TECHNICAL SERVICE BULLETIN

TSB-OT-0005

Date: October 27, 2020
To: Internal, Sales, Distribution, Sales and Service Representatives
From: Stuart Werner, Vice President, Technical Services
Subject: Missing Gasket - DBG 7.5- to 10-Ton Packaged Rooftop Product

Picture 1

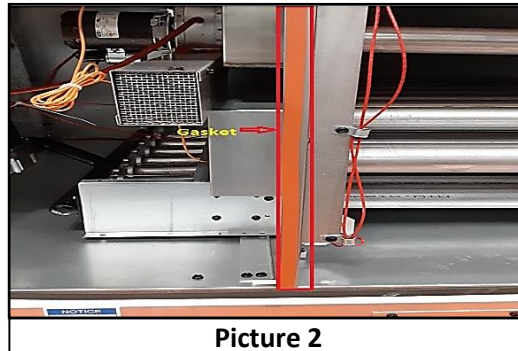
Daikin North America LLC has recently identified an issue with DBG 7.5- to 10-ton packaged rooftop units. A gasket separating the supply side from the combustion chamber was missing from the heat exchanger flange, as shown below in Picture 1. The purpose of the gasket is to prevent supply air from entering the combustion chamber and affecting heating operation as shown in Picture 2. This issue has now been corrected in production.

Picture 3

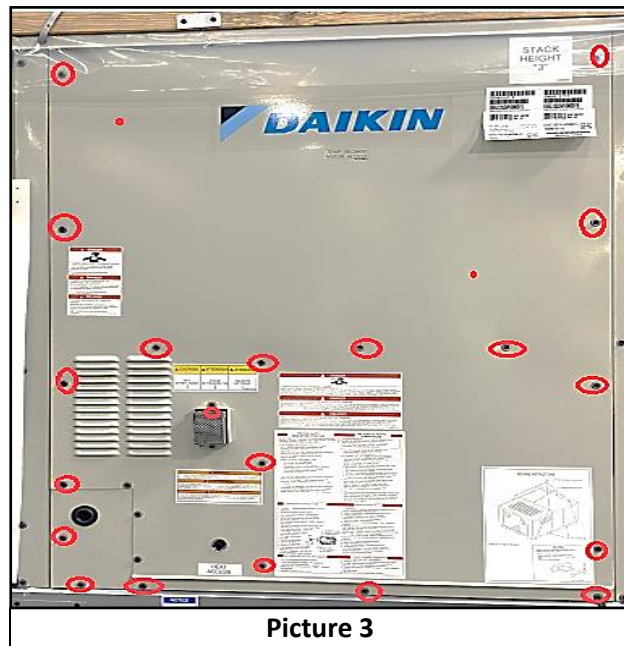
Remove the front cover panel by removing all “red” circled screws as shown in Picture 3. Carefully place the panel in the safe place/position to prevent panel scratches.

Picture 4

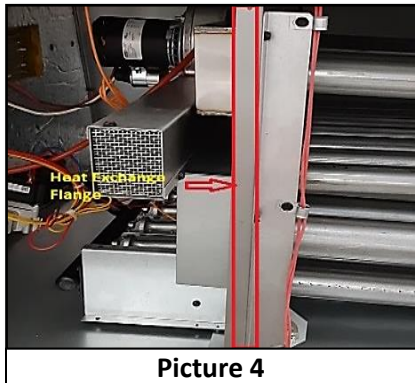
Install the seal strip (Gasket), from kit CSSKT01, to the heat exchanger flange (Picture 4) by removing the adhesive cover protection (Picture 5), and installing the gasket to the outside flange of the heat exchanger (Picture 6), ensuring that the gasket aligns with the width of the flange.
